MEMORANDUM

From:	Brigitte Crafer Landscape Architect		
Service	WBC Landscape and Trees	App No:	241567
Address:	Land To The East Of Longwater Road, Finchampstead, RG40 3TS.		
Proposal:	Full application for the proposed erection of 40no. dwellings (Use Class C3), together with associated outdoor space and landscaping, drainage infrastructure, hard and soft landscaping, parking, access, and associated works.		
Type of Development:	Major Dwellings (10+)		
Site Visit Made:	Yes/No

Fig. 1 Shows the Blackwater River Valley Valued Landscape in pink and the Finchampstead Village Area of Special Character in lilac – site outlined in red.

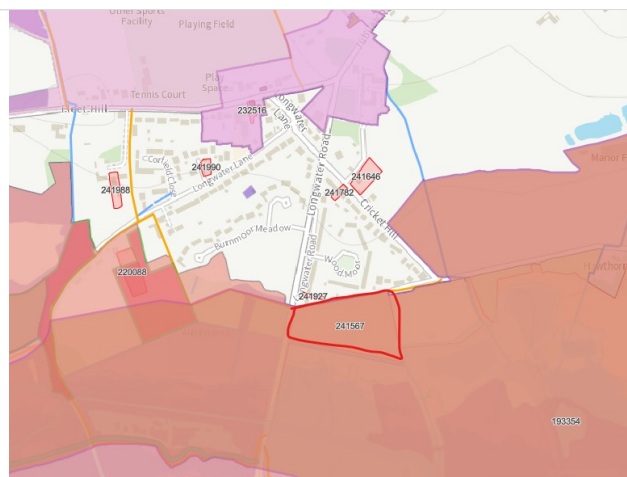
The assessment was carried out in March where the trees were mostly not in leaf. The report does not acknowledge the site is in the 'River Blackwater Valued Landscape' see Landscape Topic Paper WBC 2020, but acknowledges the site is 3km away from the 'Finchampstead Village Area of Special Character'.
